Work Order ID 108694

Item Name: Crosstube Turning Detail

DART AEROSPACE LTD	Work Order: 108694
Description: Crosstube Assembly	Part Number: D206-667-243
Inspection Dwg: D206-667-243 Rev: C	Page 1 of 2

DRAWING NO. D206-667-243	TITLE CROSSTUBE ASS'Y (206L HIGH AFT)	REV. C	DART AEROSPACE LTD ENGINEERING ORDER		D.E.O. NO. D206-667-243-C-1	SHEET NO. SHEET 1 OF 1	SCALE NTS
DRAWN 97	CHECKED ASS	MFG. APPR. RB	APPROVED MD		DE APPR. #		
DATE 11.07.15	DATE 11.07.20	DATE 11.07.21	DATE 11/07/21		DATE 11.07.21

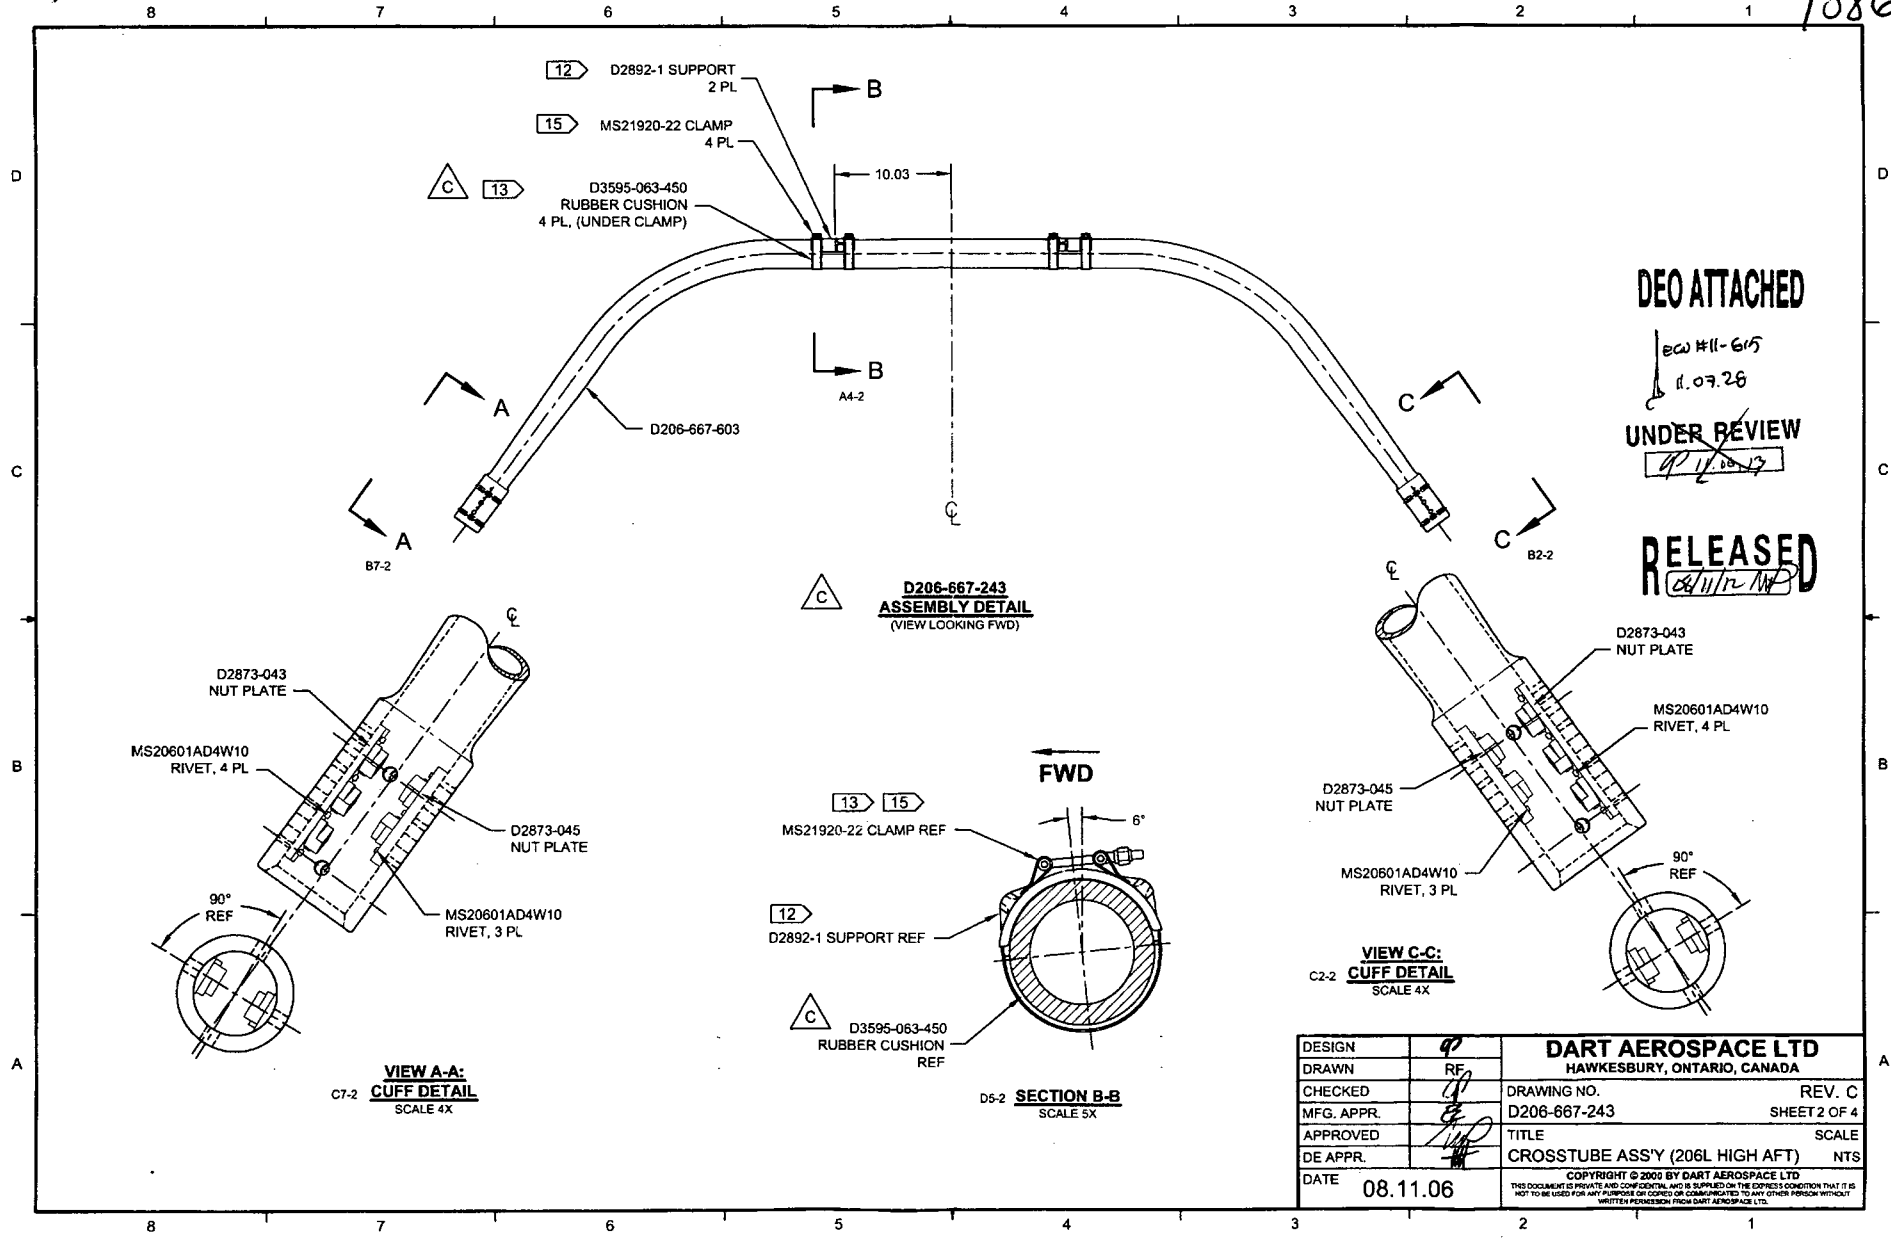
PURPOSE:
REPLACE MAGNOBOND WITH PROSEAL.

NOTE 12 & 15, SHEET 1 IS AMENDED AS FOLLOWS:

Item	Qty -243	Part Number	Description
9	A/R	PROSEAL 890 B-2	SEALANT, AMS-S-8802 CLASS B-2

- 12) TO INSTALL D2892-1 SUPPORT: ABRABE MATING SURFACE OF SUPPORT AND CROSSTUBE WITH 180-GRIT SANDPAPER AND REMOVE RESIDUE WITH MEK (OR EQUIVALENT). APPLY A 0.04" TO 0.07" THICK LAYER OF PROSEAL 890 CLASS B-2 (OR AMS-S-8802 CLASS B-2) SEALANT TO MATING SURFACE OF SUPPORT.
- 15) TORQUE CLAMPS 80 TO 100 IN-LB. ENSURE AT LEAST 1.5 THREADS SHOWING IN SAFETY AND THAT NUT HAS NOT BOTTOMED-OUT AFTER TORQUING. **PRIOR TO PACKAGING, RE-CHECK TORQUE ON CLAMPS AFTER PROSEAL 890 SEALANT HAS CURED FOR 72 HOURS.**
